Design Review Board Case #2014-0003
315 Stoval Street – Hoffman Block 2 – TSA

Application	General Data	
<p>Project Name: Hoffman Block 2 – TSA Center</p> <p>Location: 315 Stoval Street (Block 2)</p> <p>Applicant: Hoffman Management, Inc, represented by Michael J. Perine</p> <p>Architect: WDG Architecture</p>	DRB Date:	October 2, 2014
	Site Area:	3.27 acres
	Zone:	CDD#2
	Proposed Use:	Office
	Proposed Gross Floor Area:	661,387 sf
Purpose of Application:		
<p>Proposed Master Plan and CDD amendment for additional floor area and building height to allow a larger office building with above grade structured parking for the Transportation Safety Administration on Block 2 of the Eisenhower East Small Area Plan.</p>		
<p>Staff Reviewers: Thomas H. Canfield, AIA tom.canfield@alexandriava.gov Robert Kerns, AICP, robert.kerns@alexandriava.gov Gary Wagner, RLA, gary.wagner@alexandriava.gov Trey Akers, Planner II, trey.akers@alexandriava.gov</p>

Figure 2

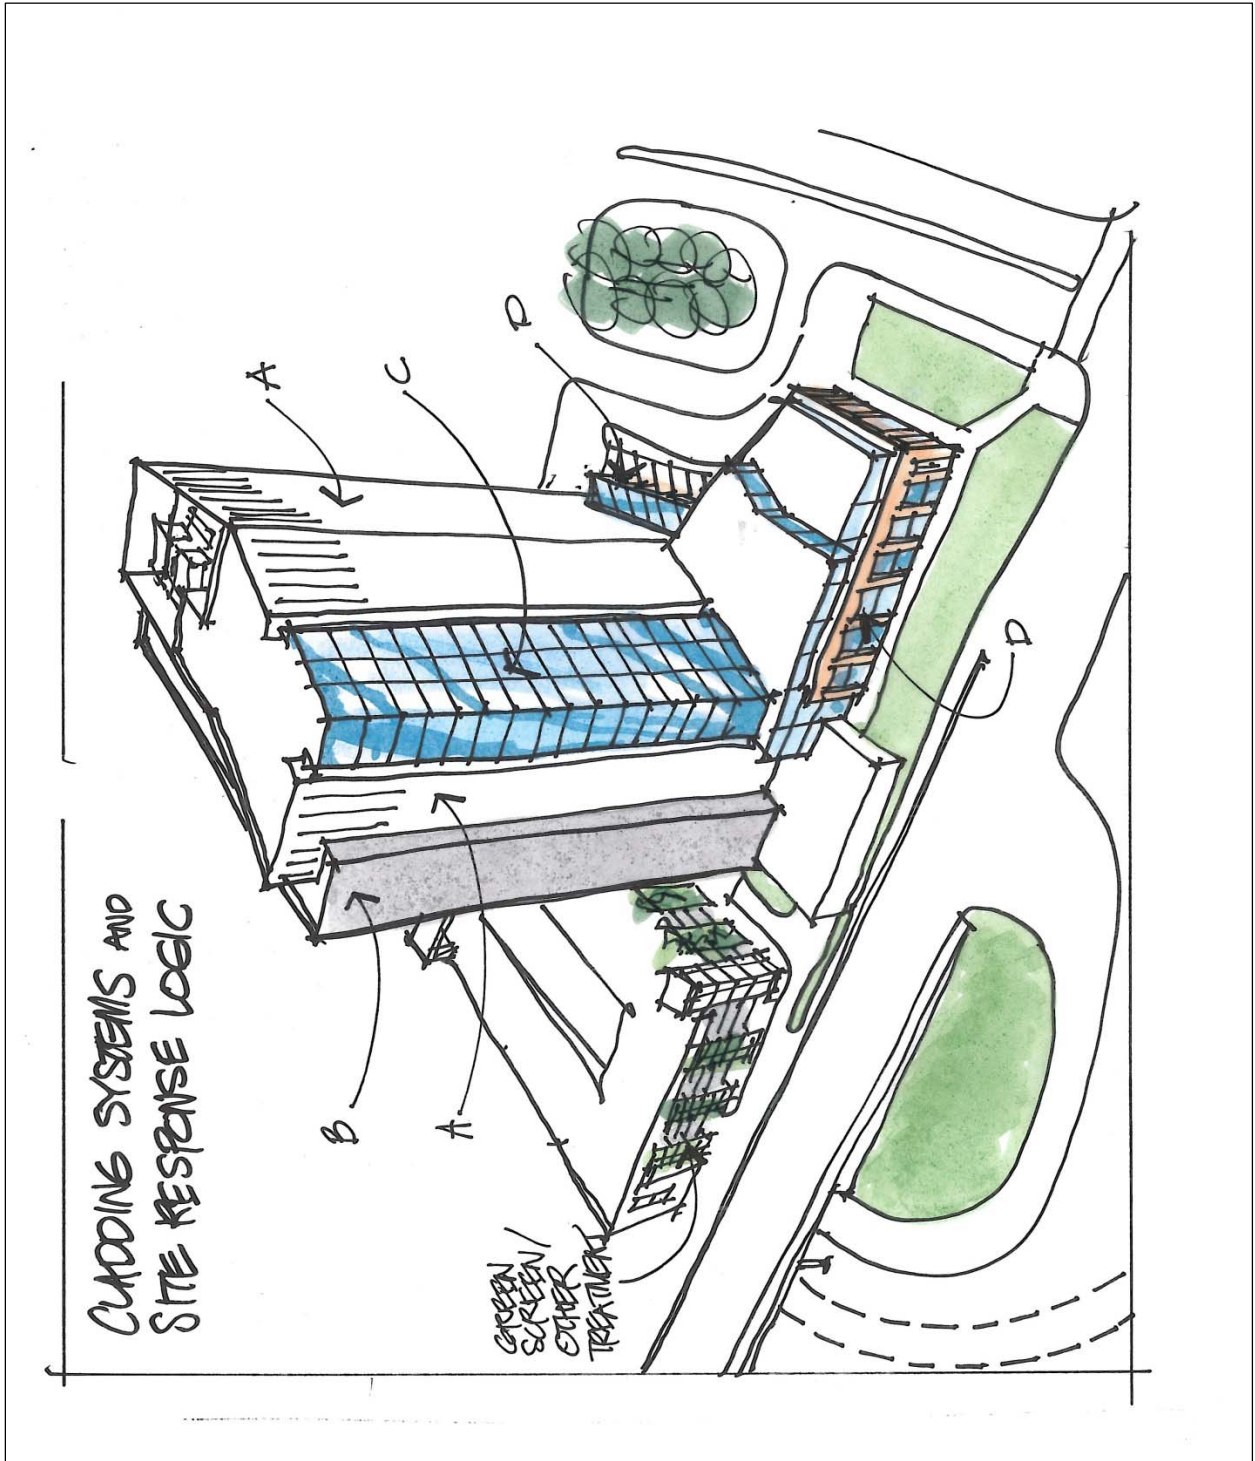
As currently represented, however, the design falls short of putting its best elements forward in several key areas (see Fig. 2). As well-proportioned and detailed as the two-story entry feature is that wraps the arrival space on the northeast corner of the site, the three story projecting element that holds the streetwall at Eisenhower and Stovall appears in contrast to be almost utilitarian in character. There are similar concerns about the more prominent faces and corners of the large above-grade parking structure.

Figure 3

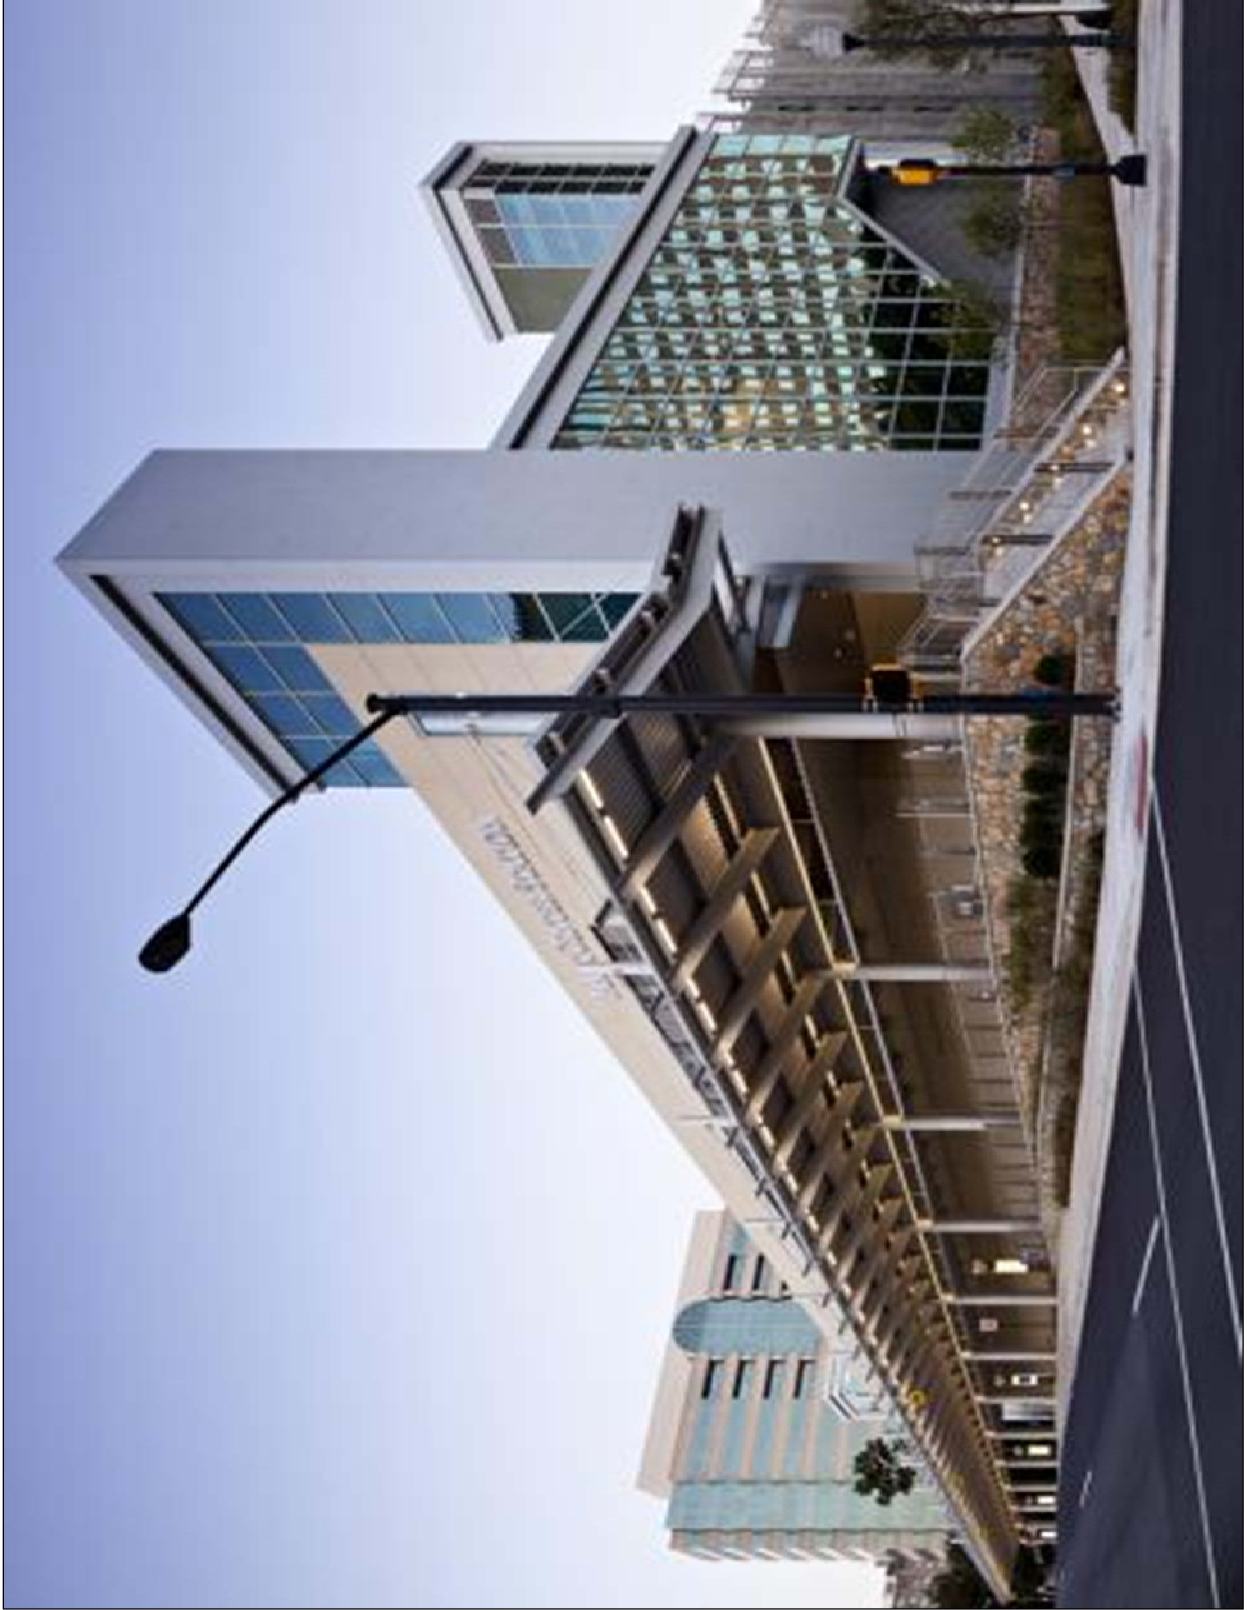
The design offers the potential to provide stronger and more appropriate responses to its context through some additional refinements. One approach that could be considered is summarized graphically below (see Fig. 3) and illustrates staff’s belief that most of these issues can be successfully addressed using design elements that are already part of the composition. To summarize the direction that is suggested:

- a. To better address the civic presence of the building in the urban space of Eisenhower Avenue and the key approach westbound from the Metro, study wrapping the two-story entry language around the entire projecting element at the southeast of the building (“D” in Fig. 3). There appears also to be the potential to make some minor internal spatial rearrangements (i.e., switch the Security Operational and Broadcast Studio areas with the Fitness Center) so that all of the functions that might be seen through this more glassy element would be more public and active in character (Cafeteria and Fitness Center). In keeping with the third floor reveal that sets off the stone base at the building entry, any third floor portions of this projection could also be rendered in glass, to emphasize the strong base.

- b. The corner glass insert at the southeast corner of the main tower, clearly intended as well to address the primary approach to the building, may be too understated; one approach to strengthen it (“C” in Fig. 3) might be to carry it all the way up the tower, so that it could read as the third tower component. Such an element could also be used to create a stronger skyline feature, by carrying it above the rest of the tower

roof, if desired. This embedded glass form might also read as an outgrowth of the glass elements suggested for the projecting three-story corner piece.
